COUNCIL MEETING
MONDAY 7 NOVEMBER 2022

7.1 DEVELOPMENT APPLICATION PDPLANPMTD-2022/030063 – 28 BURGUNDY ROAD, HOWRAH - 2 MULTIPLE DWELLINGS**EXECUTIVE SUMMARY****PURPOSE**

The purpose of this report is to consider the application made for 2 Multiple Dwellings at 28 Burgundy Road, Howrah.

DRIVEWAY PLAN

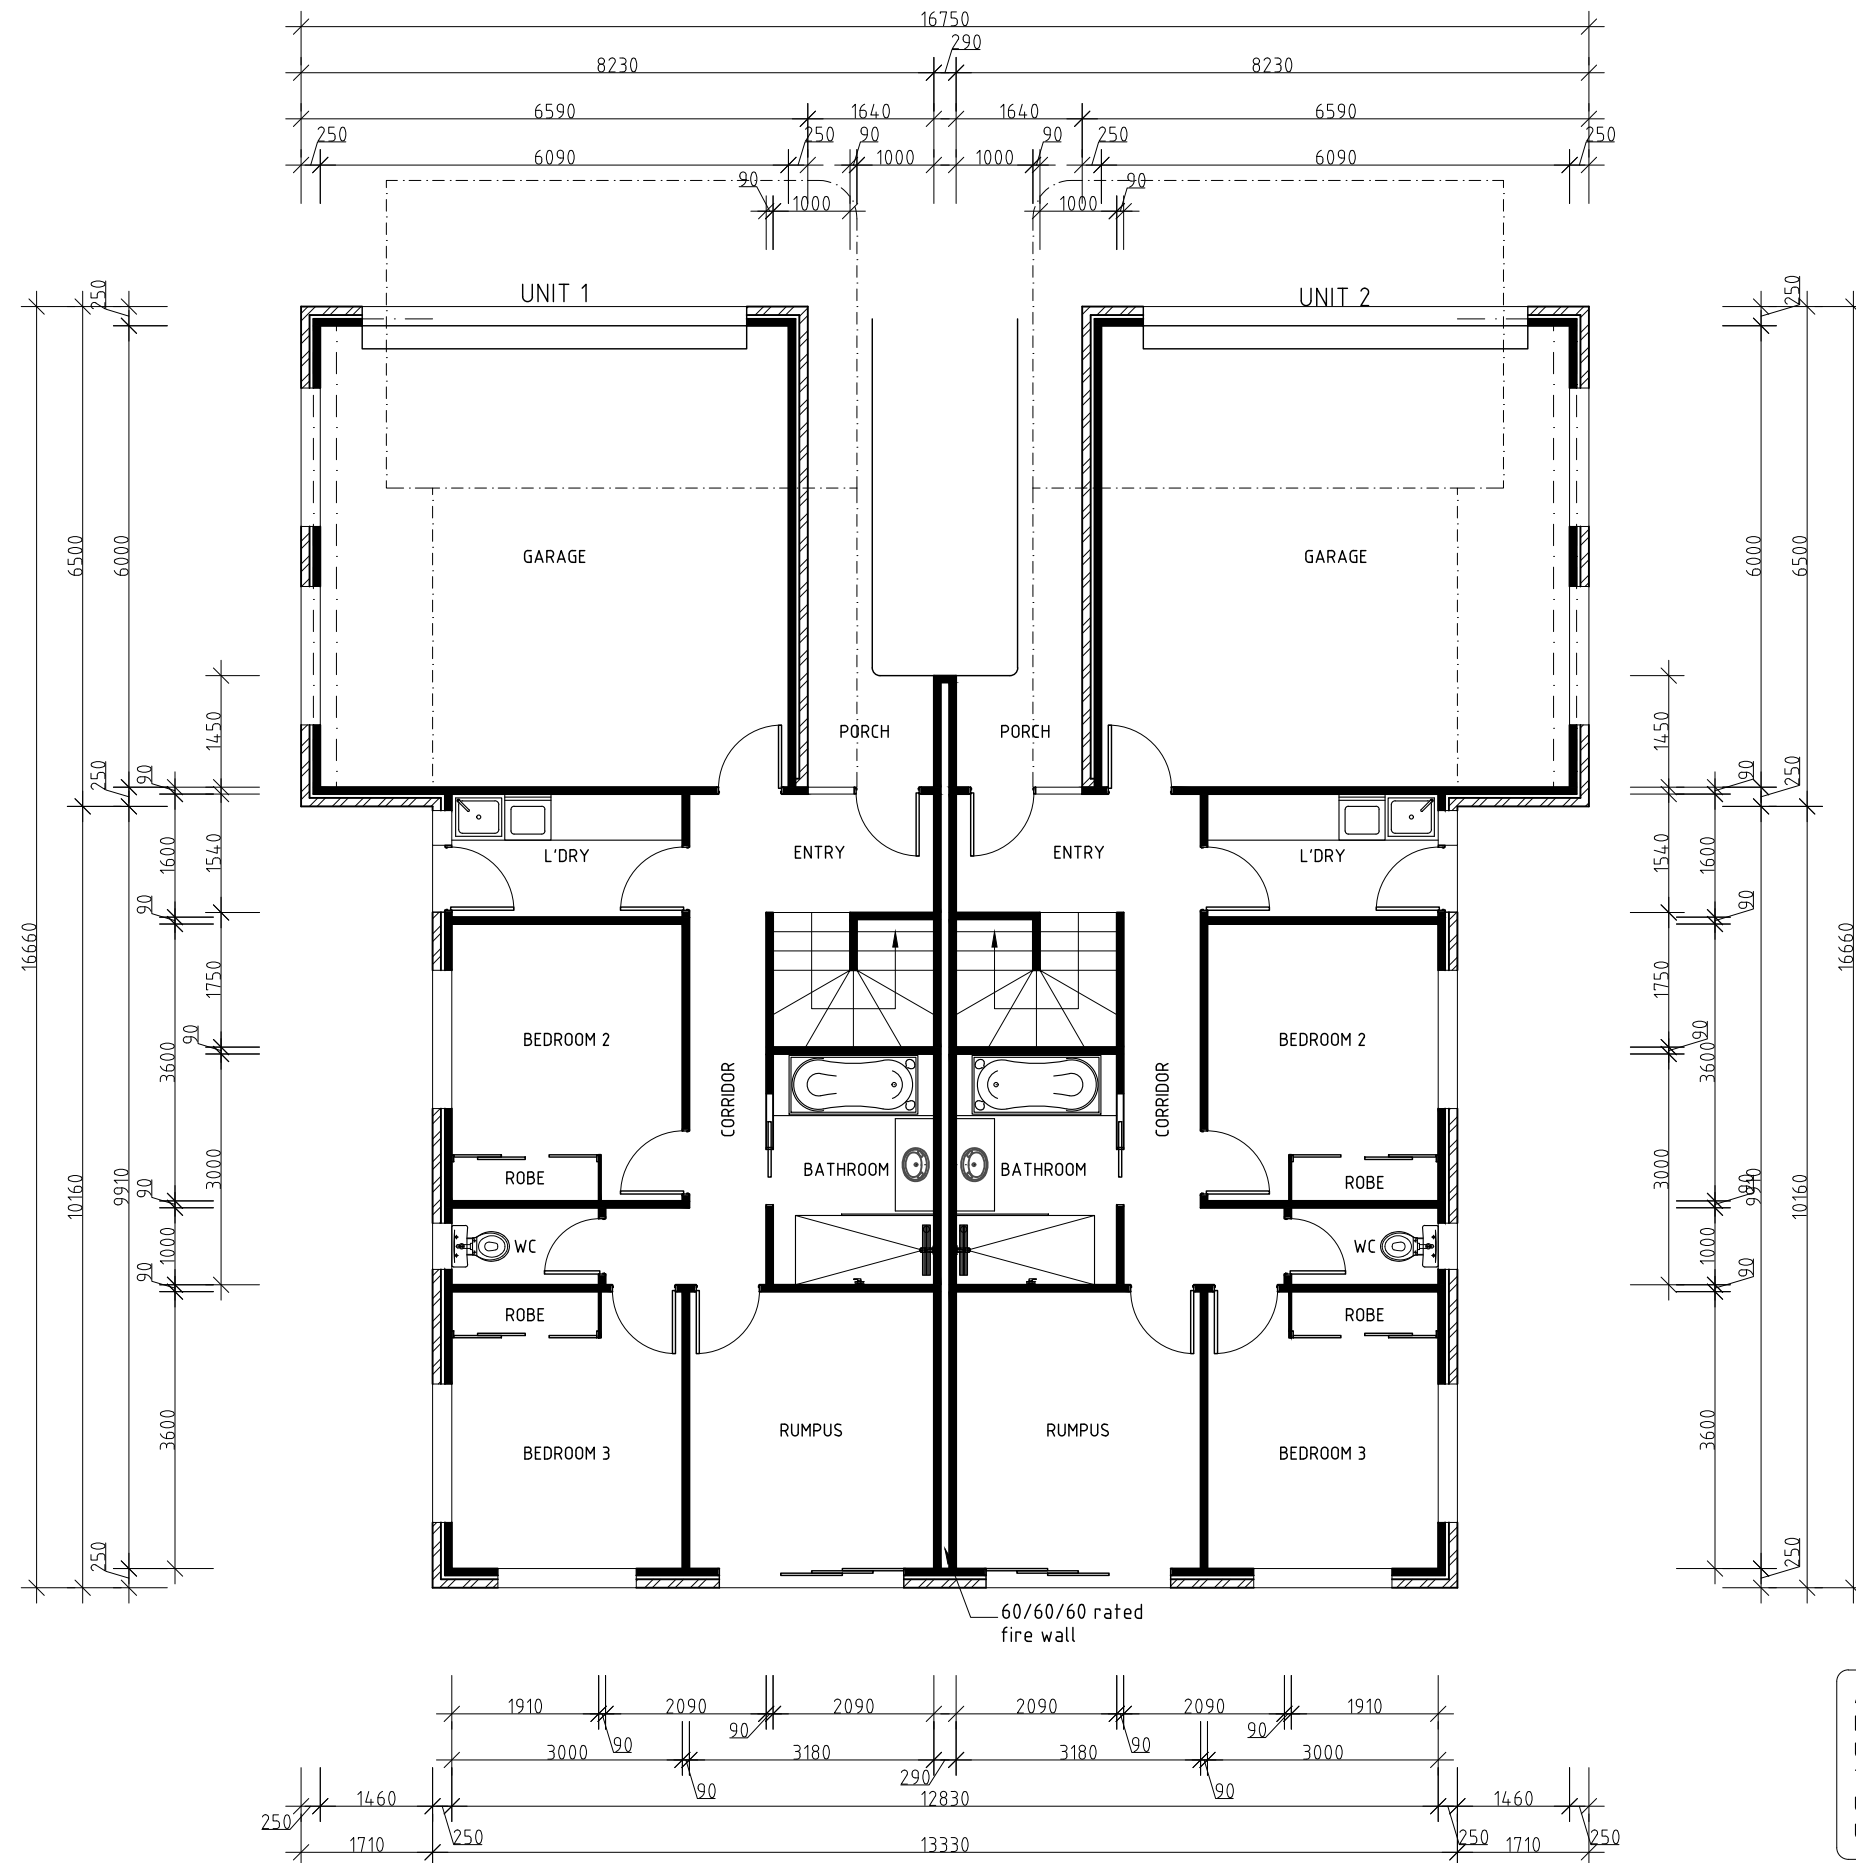
A shared access from Burgundy Road is proposed to provide vehicle access to the garages servicing each dwelling. Each dwelling is provided with two carparks and a shared visitor park located between the dwellings and the street.

This development is a 2-storey conjoined building arrangement, setback 8.666m from the street and separated from the street by a substantial sealed access area.

The size of the building setback and the dominance of the sealed area between the building and the frontage will disrupt the appearance and the rhythm of the streetscape. However, with some minor modifications, this could be largely overcome. This is discussed later in the report.

1. GEN AP1 – ENDORSED PLANS.
2. Amended plans showing the provision of two separate access points and driveways to service each multiple dwelling must be submitted to and approved by Council's Manager City Planning prior to the commencement of the use/development. The access points must be located and designed to maximise the ability for on-street parking and landscaped areas between the dwelling and the street frontage. When approved, the plans will form part of the permit.

5. A 3.6m wide kerb and gutter crossing must be provided to each dwelling and must be constructed in accordance with Standard Drawing TSD-R09. A 3.6m wide sealed access is required to be constructed from the road carriageway to the property boundary for each dwelling to accord with Standard Drawing TSD-R09 (copy available from Council). The driveway may reduce to 3.0m over the remaining length of the driveway for each dwelling. This access must be inspected by Council prior to sealing or pouring new concrete.

June 21 – 1 PM – Comparison With Number 28 Shadows and No Shadows

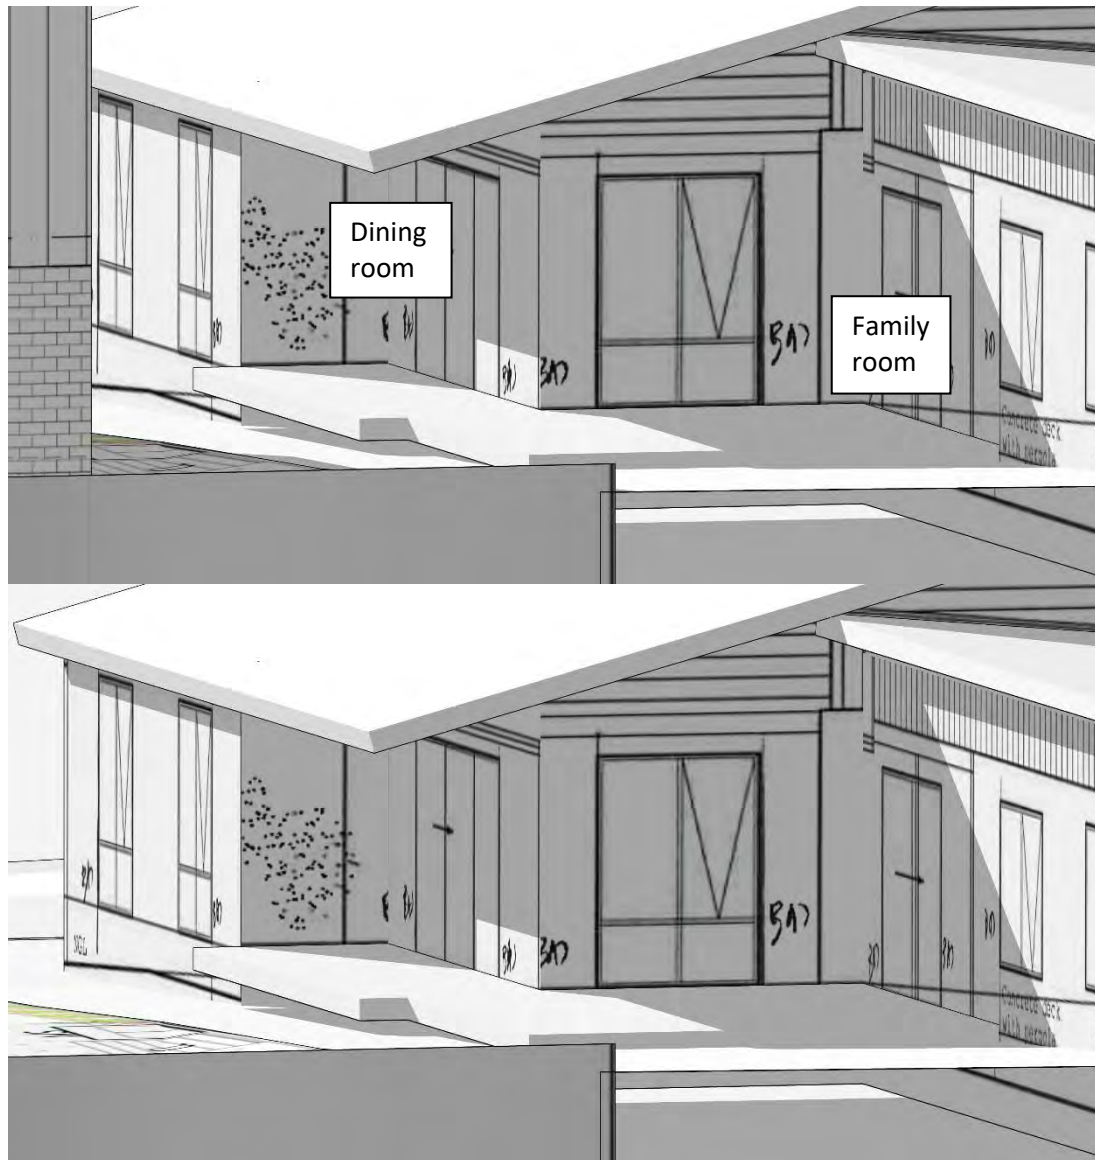
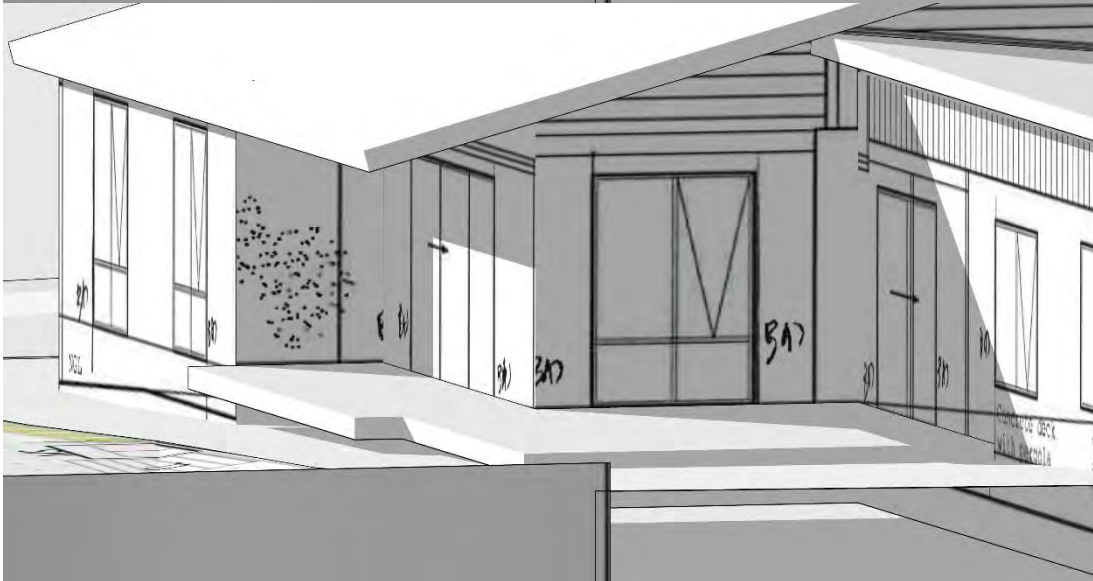
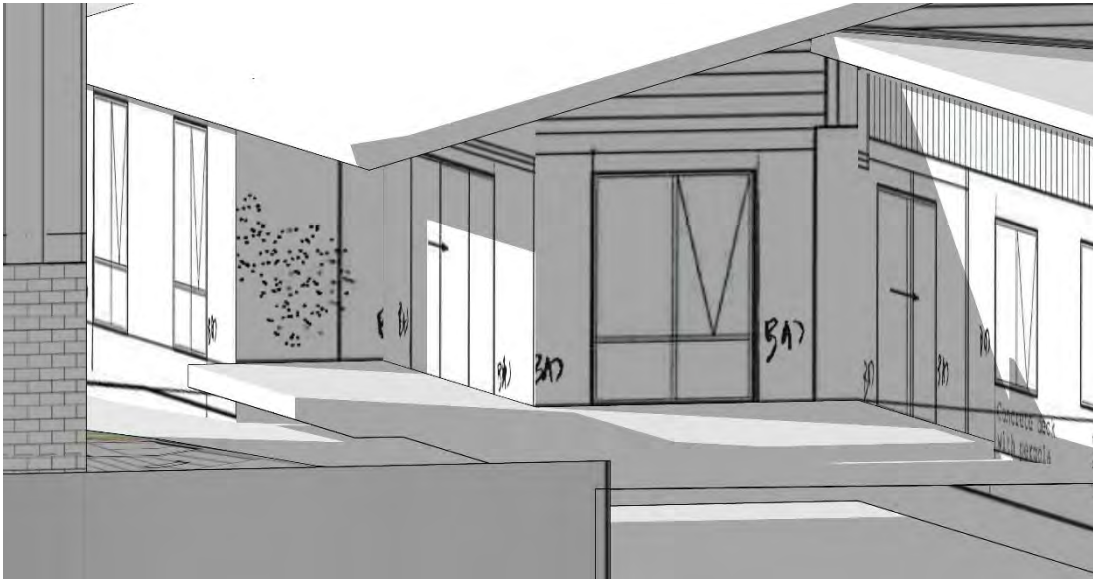
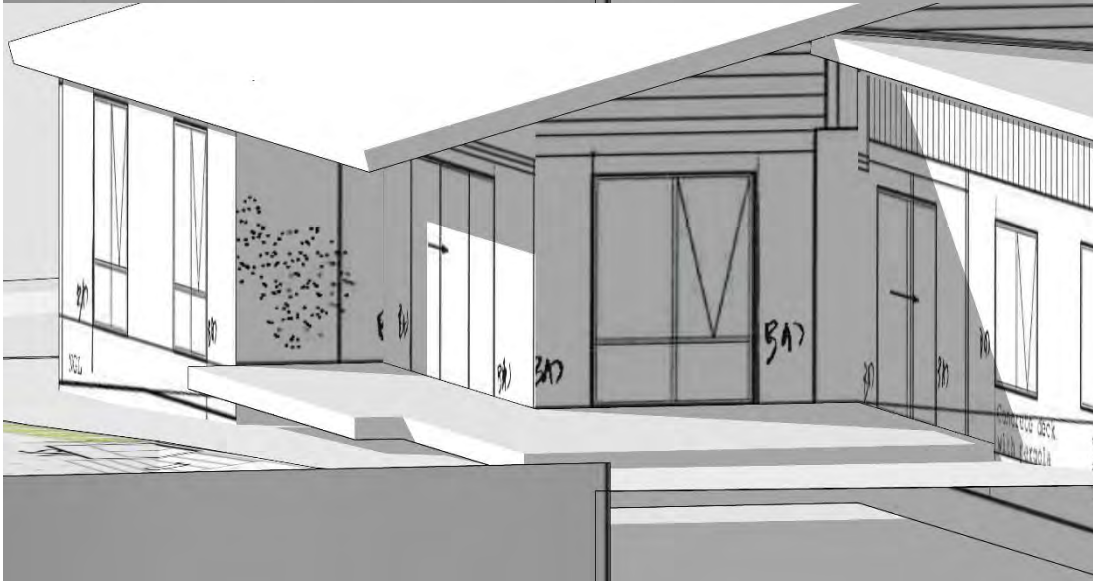
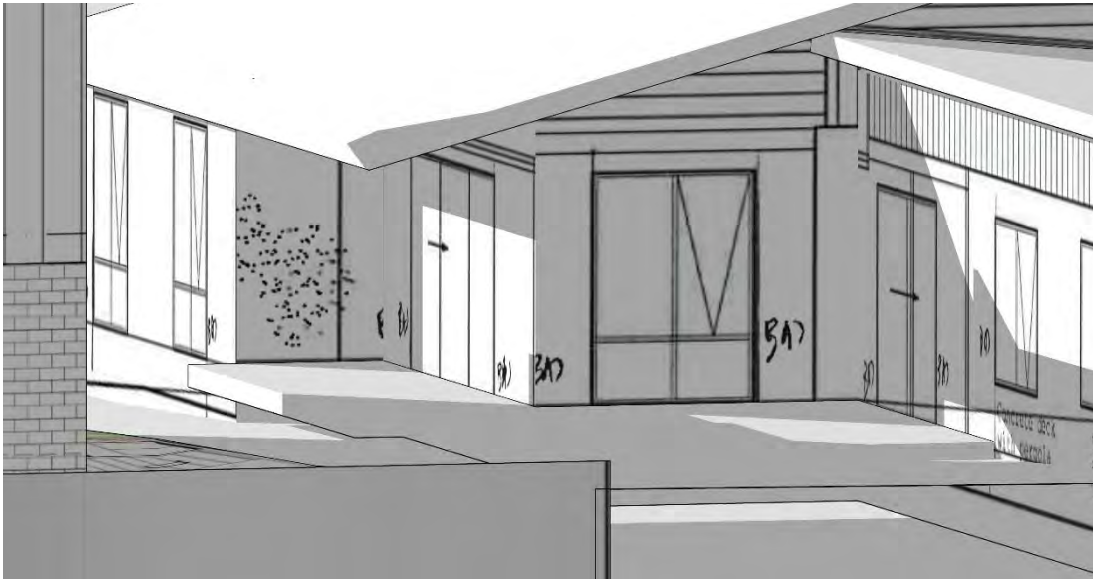
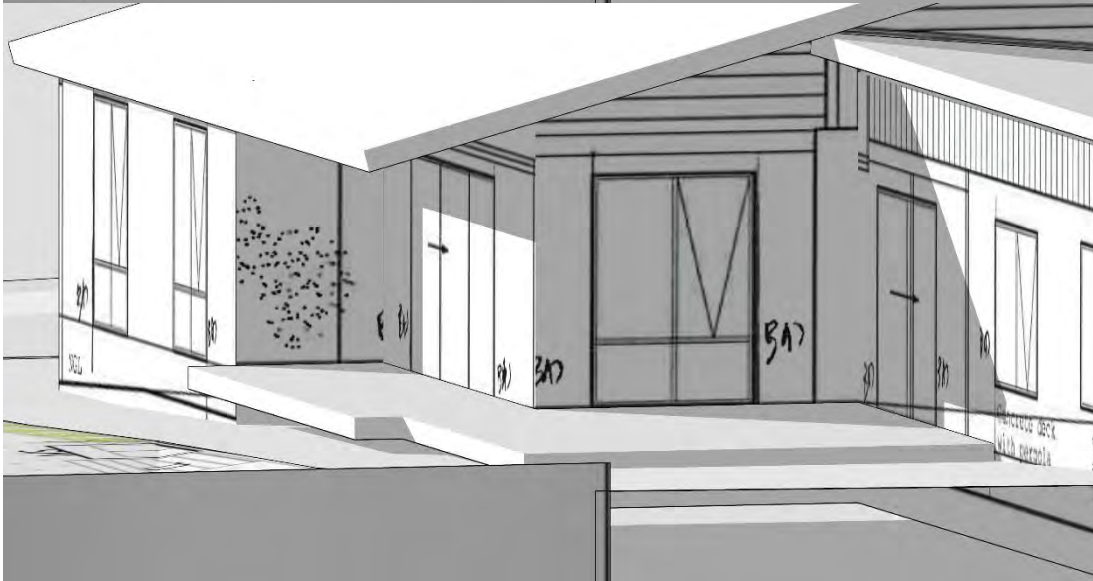
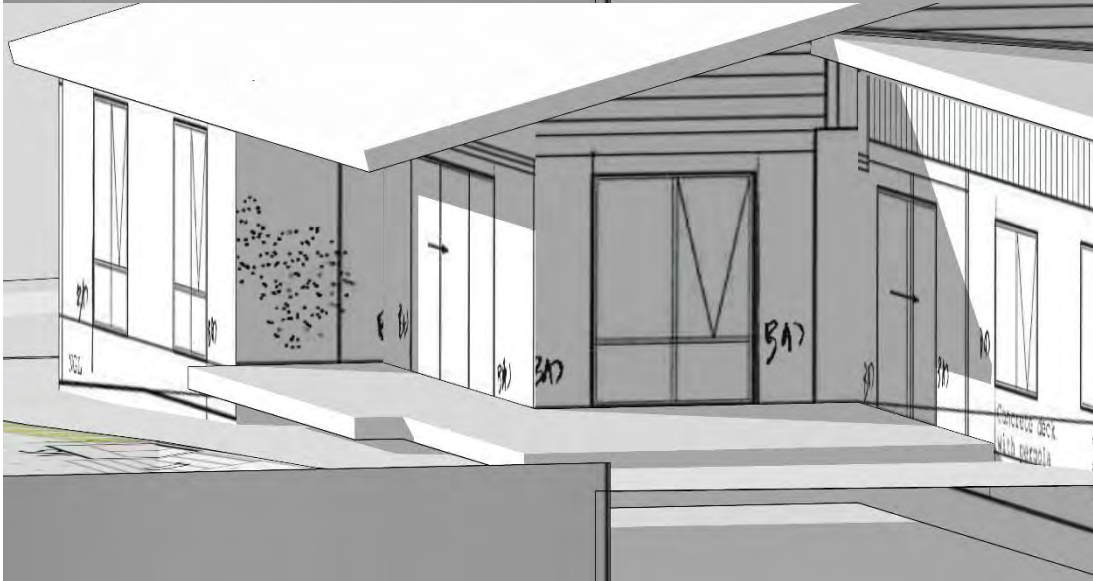
| | | <p>The supplementary diagrams demonstrate these windows will not be subject to any additional overshadowing impact caused by the proposed development, as these windows are in shadow of the dwelling on 30 Burgundy Road due to the dwelling's configuration.</p> <p>For the above reason the test of subclause (a) is met by the proposal.</p> |

An assessment of overshadowing impact upon adjoining properties is provided in detail under Section 4.4 of this report and is considered to satisfy the associated performance criteria P3, in that the supplementary shadow diagrams show that there would be no additional overshadowing of habitable room windows of adjoining dwellings nor any unreasonable loss of sunlight to the private open space of these adjoining dwellings.
